Permit Number: 118219
Issued This Date: 01/24/2025
This permit is hereby given to: James & Alesia Forehand

9063 FAWN CREEK DR
SPRING BRANCH, TX 78070

SITE PLAN & OSSF DESIGN

SITE PLAN & OSSF DESIGN

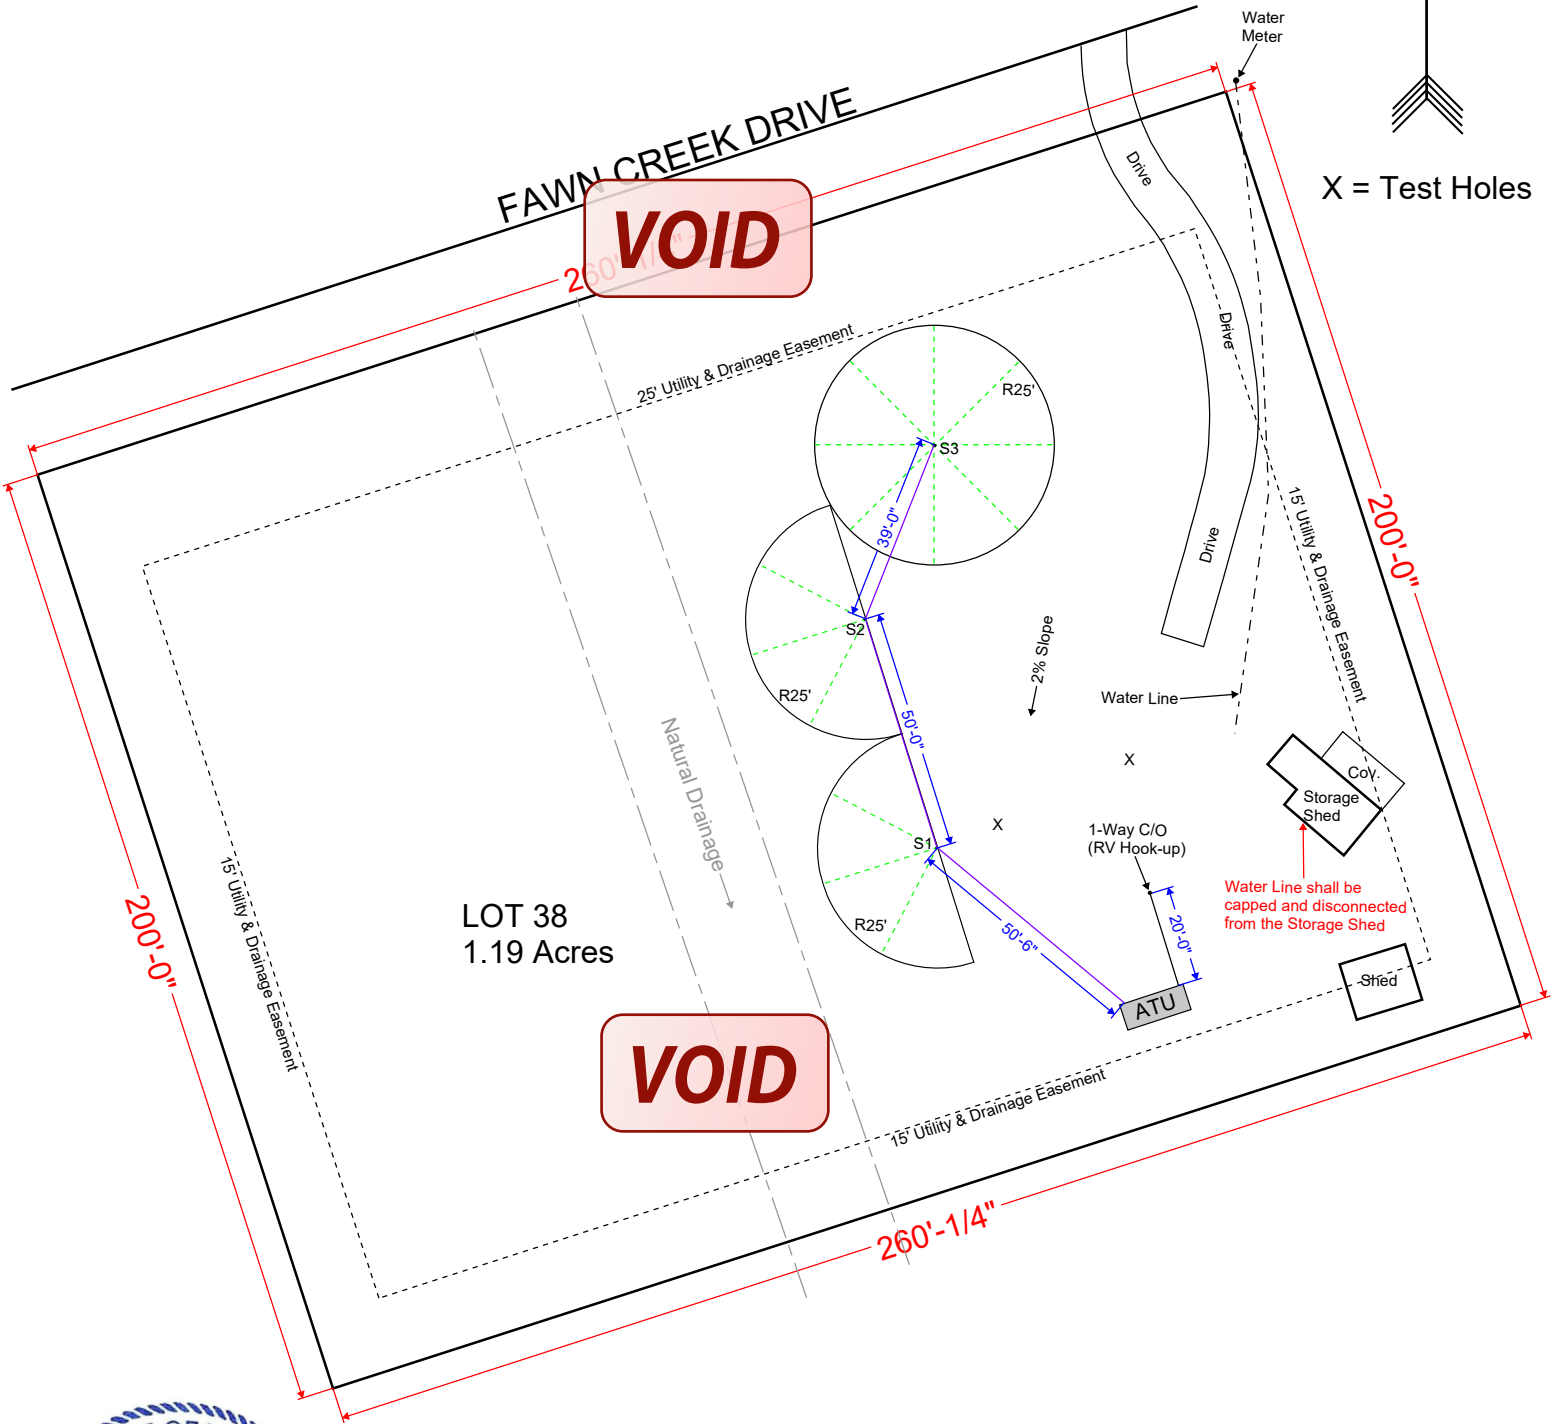
The attached  page must be updated to match the design which was revised to Clearstream.
